PARTIAL PUMP ROOM FLOOR PLAN
ELECTRICAL — DEMOLITION
NOT TO SCALE

PARTIAL PUMP ROOM FLOOR PLAN
ELECTRICAL — NEW WORK
NOT TO SCALE

REV. A — ADDENDUM #1	3/21/12	<div><div>Tennessee Valley Healthcare System</div></div>	 <div>Approved: —</div> <div>Approved: —</div>	Drawing Title PARTIAL PUMP ROOM PLAN- ELECTRICAL Approved: Facility Manager Approved: Director	Project Title REPLACE ATTIC AHU'S- BLDG 6 Building Number 6 Checked JJB Drawn AL Location VAMC — MURFREESBORO	Date 03/21/2012 Project No. 626A4-11-204 DRAWING NO. 6-E5 FILE NAME —	Veterans Administration
----------------------	---------	--	---	--	---	--	----------------------------

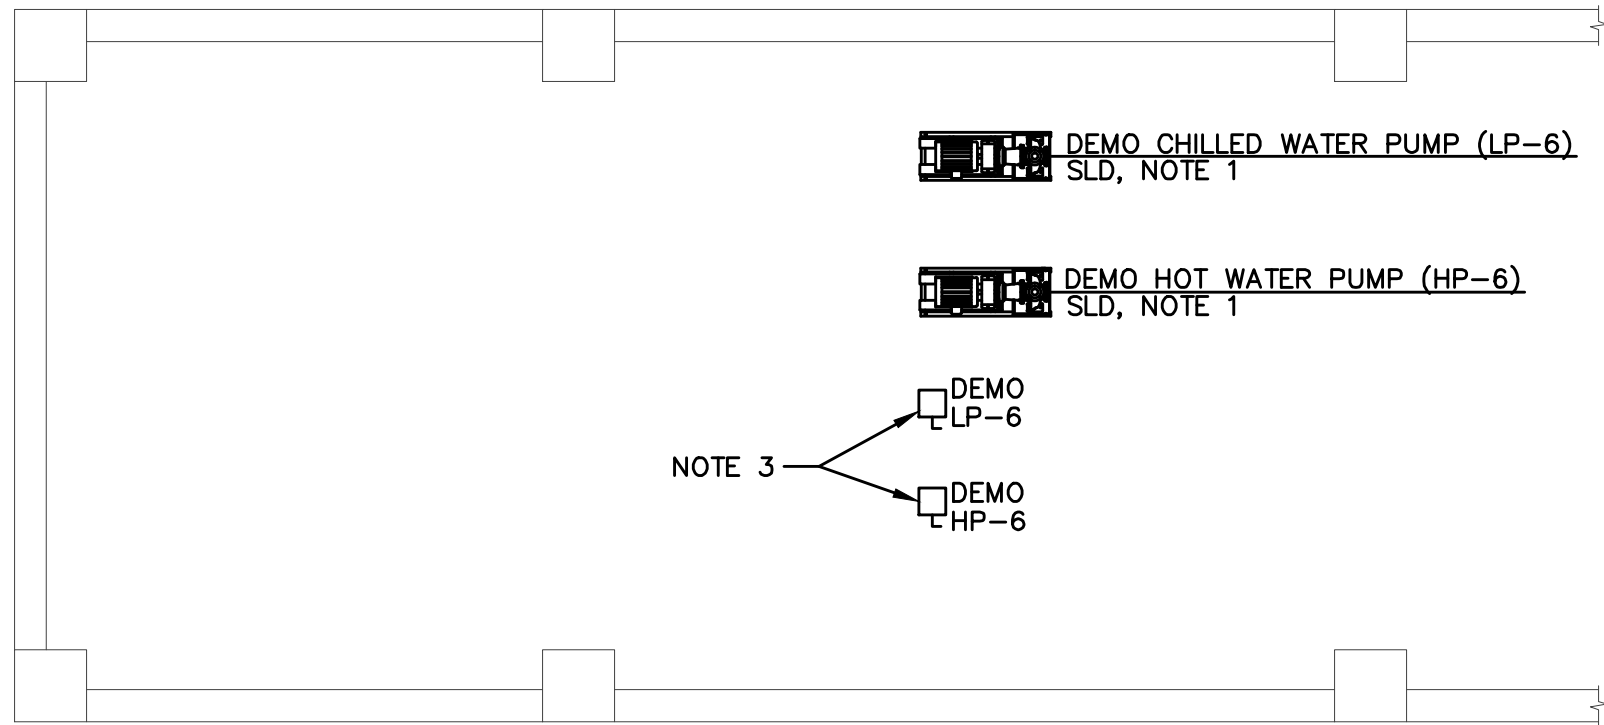
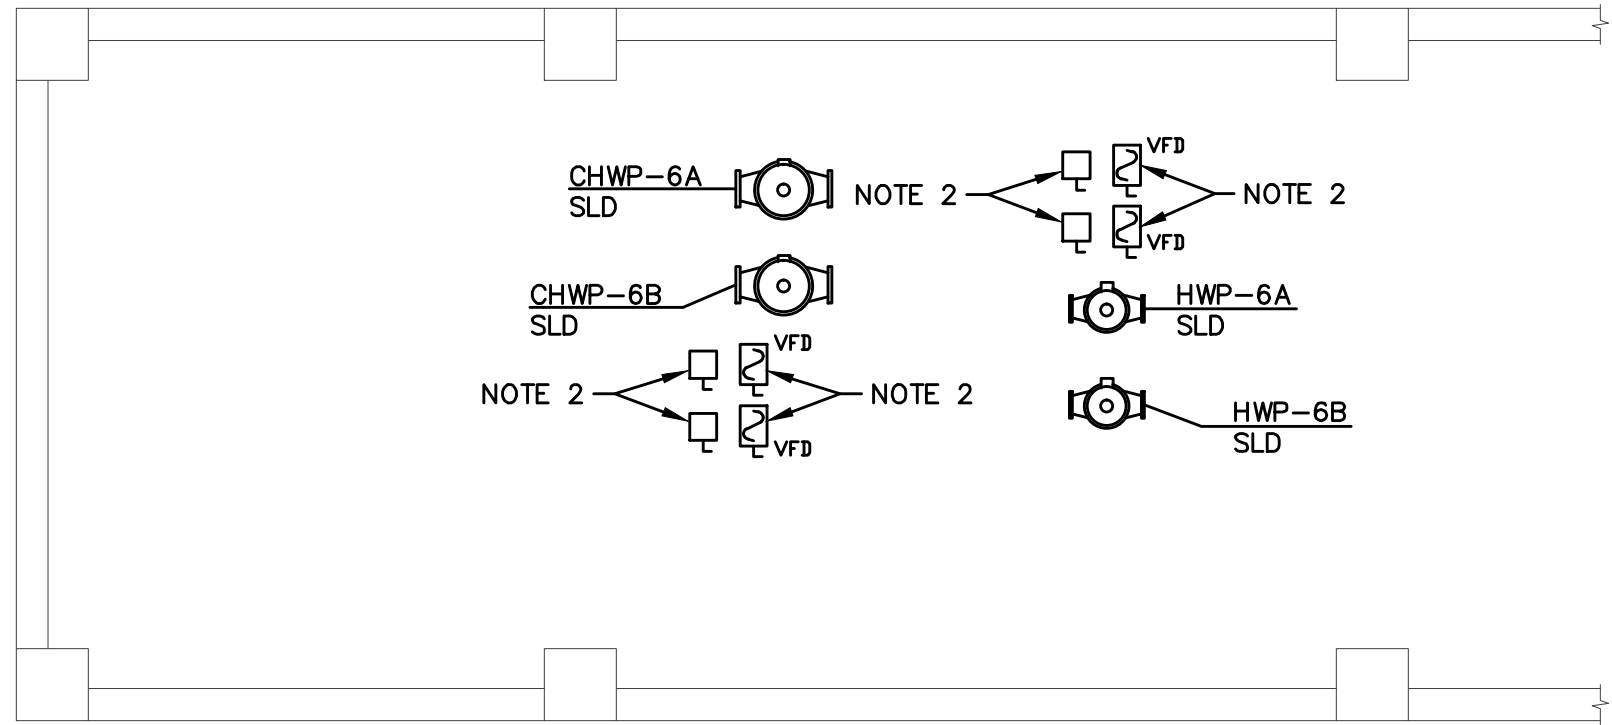
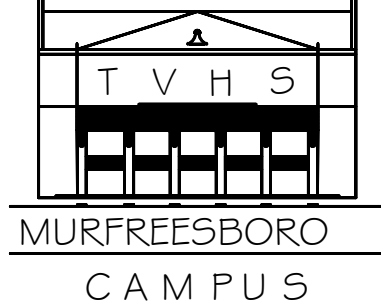
1. REMOVE DISCONNECT SWITCH FOR PUMPS. REMOVE CONDUCTORS AND CONDUITS BACK TO MOTOR CONTROL CENTER (MCC-6120) LOCATED ON GROUND FLOOR OF MECHANICAL ROOM G11. MARK COMBINATION CIRCUIT BREAKER/STARTER "SPARE".
2. INSTALL VFD AND DISCONNECT SWITCH ON UNISTRUT. SUPPORT UNISTRUT FROM FLOOR. SEE DETAIL ON SHEET 6-E1. COORDINATE EXACT LOCATION WITH MECHANICAL CONTRACTOR AND EQUIPMENT.
3. REMOVE EXISTING DISCONNECT SWITCHES AND MOUNTING STRUCTURE.
